SANDSTONE PRECINCT THE DEPARTMENT OF LANDS

EXISTING LATH AND PLASTER CEILING REVIEW

RTS RESPONSE - ITEM 4.

LOWER GROUND FLOOR

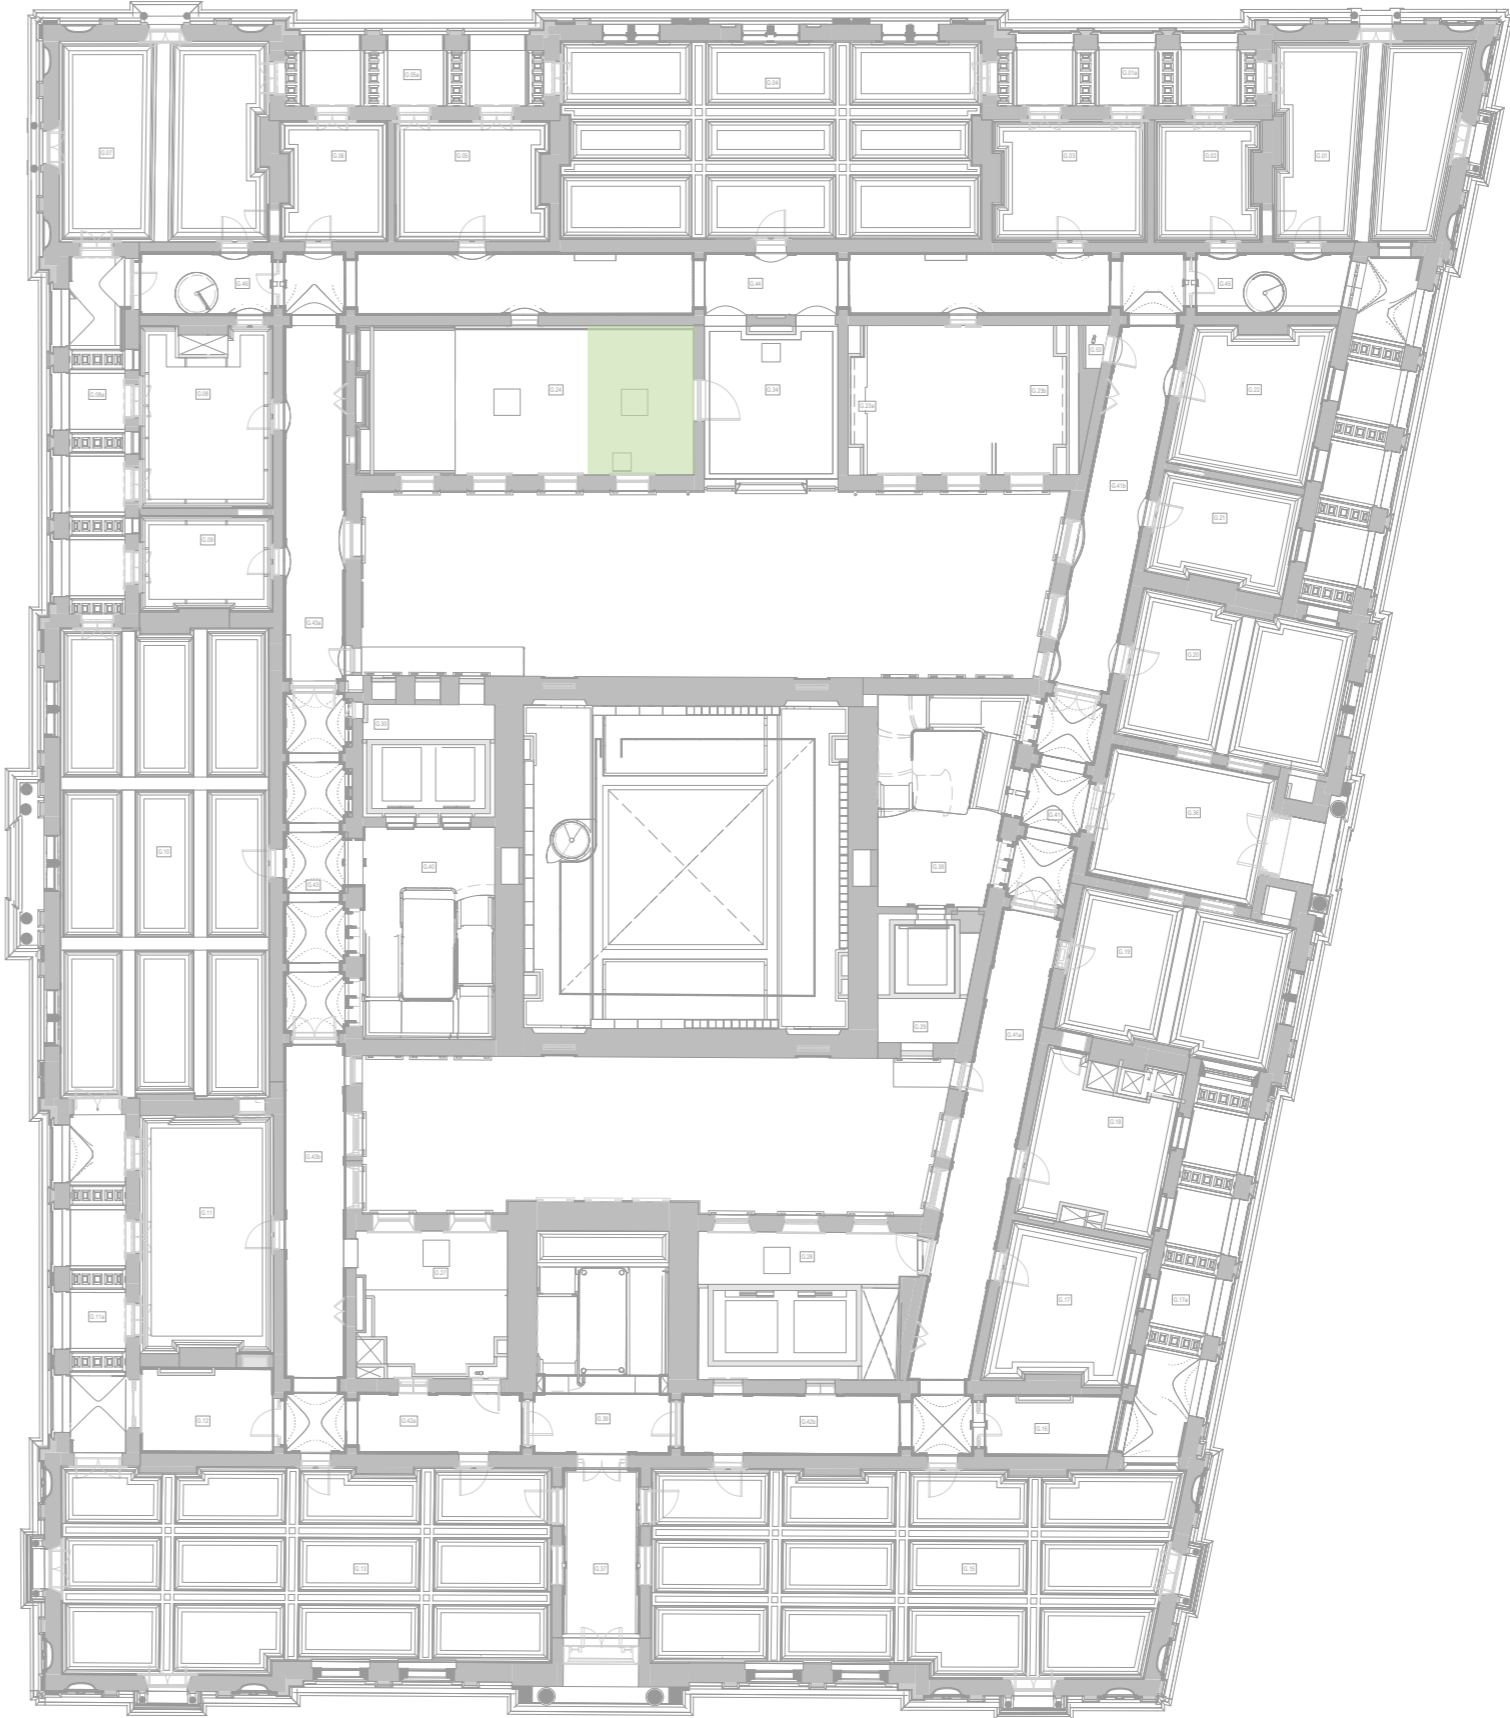
Confirm the proportion of ceilings across the lower ground, ground and level 1 which are original and non-original (ie. have been replaced in the past). This detail is to be as accurate as feasible, informed by surveys (and any further surveying undertaken).

Of the approximate 1,759m² of ceilings currently available for inspection (from above) approximately 164m² of original ceiling linings have been replaced with modern linings.
